Access Compliance Report

Public Rights-of-Way

Intersection ID: 10022634	Main Street: CARMEL_RD	Cross Street: N/A	Location: SE
ADA ID: CD3AC2CBFBF5	Ramp Type: PerpDiag	Initial Pass/Fail: Fail	Overall Compliance: No
Severity Score: 12.5			
Codes/Mitigation Info/Possible Solution		Field Measurements/Component Compliance

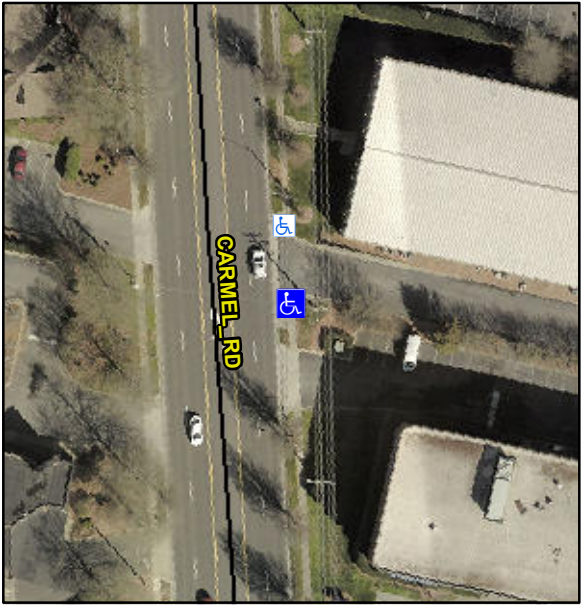
Possible Solutions:	Compliance	Description	Data	Compliance	Description	Data
	Remove & Replace Curb Ramp With Two New Directional Ramps or Equivalent.	N/A	Ramp Length (in)	86.0	Yes	Ramp Slope (%)	7.0
		Yes	Ramp Width (in)	48.0	No	Ramp XSlope (%)	6.0
		N/A	Flare Type LT	N/A	N/A	Flare Type RT	N/A
		N/A	Flare Slope LT (%)	N/A	N/A	Flare Slope RT (%)	N/A
		N/A	Flare Traversable LT?	N/A	N/A	Flare Traversable RT?	N/A
		N/A	Landing Length (in)	N/A	N/A	DWS Provided?	N/A
		N/A	Landing Width (in)	N/A	N/A	DWS Contrast?	N/A
		N/A	Landing Slope (%)	N/A	N/A	DWS Length (in)	N/A
		N/A	Landing X Slope (%)	N/A	N/A	DWS Full Width?	N/A
<p>Surveyor Notes:</p> <p>N/A</p> <p>PROW/ADA:</p> <p>Not Found, R304.5.3</p>		N/A	Landing Curb? (Y/N)	N/A	N/A	DWS Offset (in)	N/A
		N/A	Shared Landing?	N/A			
		N/A	Gutter Ponding?	N/A	N/A	Gutter Slope (%)	N/A
		N/A	Gutter Lip Ht (in)	N/A	N/A	Gutter X Slope (%)	N/A
		N/A	Painted X Walk1?	No	N/A	Painted X Walk2?	No

X Walk 1 Direction	To N		X Walk 2 Direction	To W
		N/A	X Walk 1 Width (in)	N/A	N/A	X Walk 2 Width (in)	N/A
			X Walk 1 Slope (%)	0.0		X Walk 2 Slope (%)	0.7
			X Walk 1 X Slope (%)	6.6		X Walk 2 X Slope (%)	1.0
		N/A	Ramp inside XWalk1?	N/A	N/A	Ramp inside XWalk2?	N/A
<p>Street 1 Name</p> <p>Stop Condition-Street 2</p> <p>Street 2 Name</p> <p>Stop Condition-Street 1</p>	ENTRANCE <p>None</p> <p>CARMEL RD</p> <p>None</p>		Road Slope (%)	3.6	N/A	Clear Space?	N/A
			Road X Slope (%)	5.3	N/A	Clear Space to XWalk (in)	N/A
		N/A	Any Obstructions?	N/A	N/A	Storm Grate/Utility Hazard?	N/A
			Obstruction Type			Storm Grate/Utility Type	
					N/A		N/A
					Yes	Surface Condition? (G/P)	Good
Total Cost:		\$	3200.00
